SERVICE BULLETIN

Fiat 126

Main Data

Differences with respect to previous version

« 126 Personal »

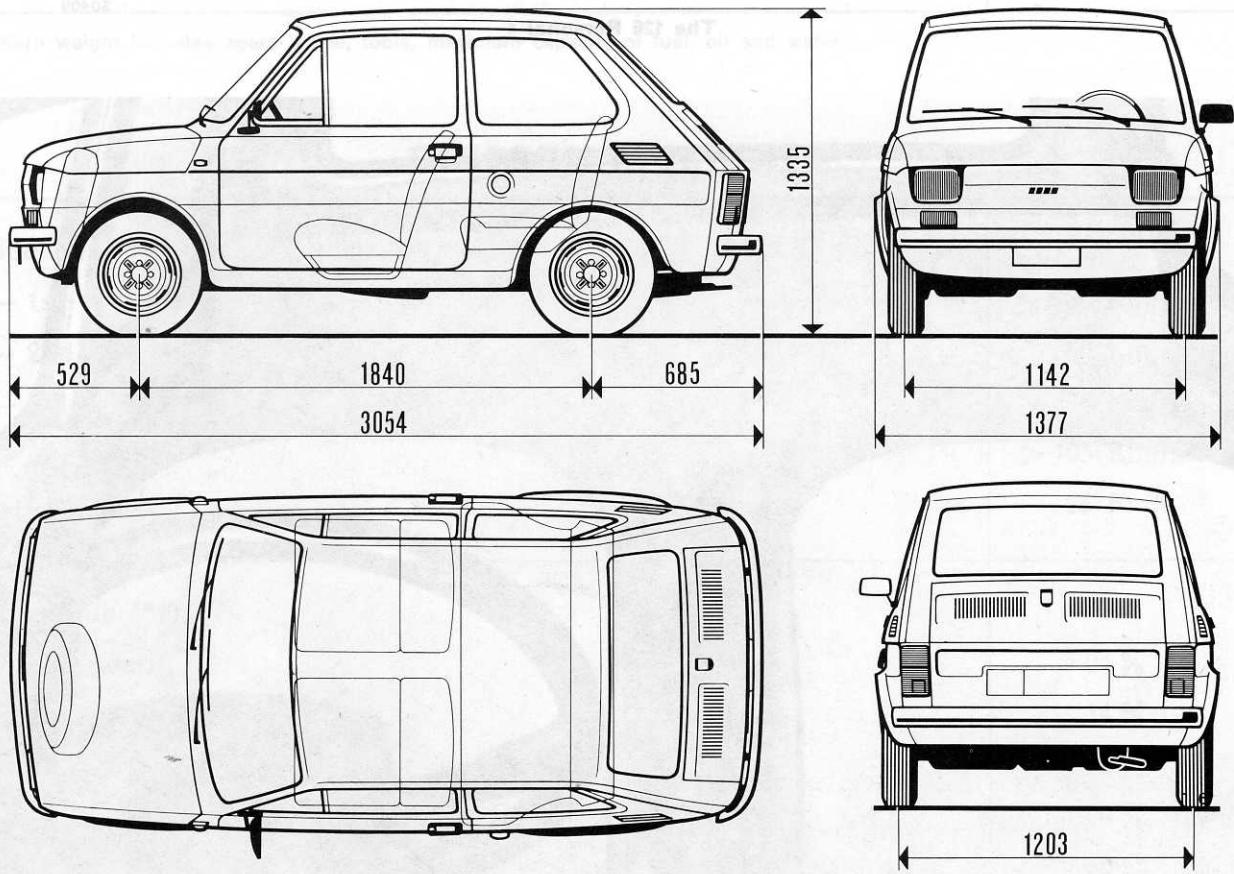
Differences with respect to 126:

- Black finish, elastic resin front and rear bumpers
- Two section rubber side bumpers
- Windscreen wiper arms and blade carriers in matt black finish
- Front hinged rear ventilators
- Instrument panel fully carpeted
- Sun visors with map pocket, driver's side, and vanity mirror, passenger's side
- Gear lever knob in foam rubber
- Handbrake handle in black plastic
- Revised front seats

- Velvetten or luxury imitation leather seat coverings
- Glove box provided with radio loudspeaker housing
- Rear seat consisting of removable cushion lined with zip-fastened case and padded band acting as seat back
- Rear side pockets near wheel arches
- Rear armrests are no more provided
- Floor and door/rear quarter trim pads are fully carpeted
- Plastic rear shelf
- Differences with respect to 126 Personal:
 - 126 «Base» rear seat design with «Personal» seat coverings
 - Rear quarter trim pads with armrests
 - Side pockets are not provided
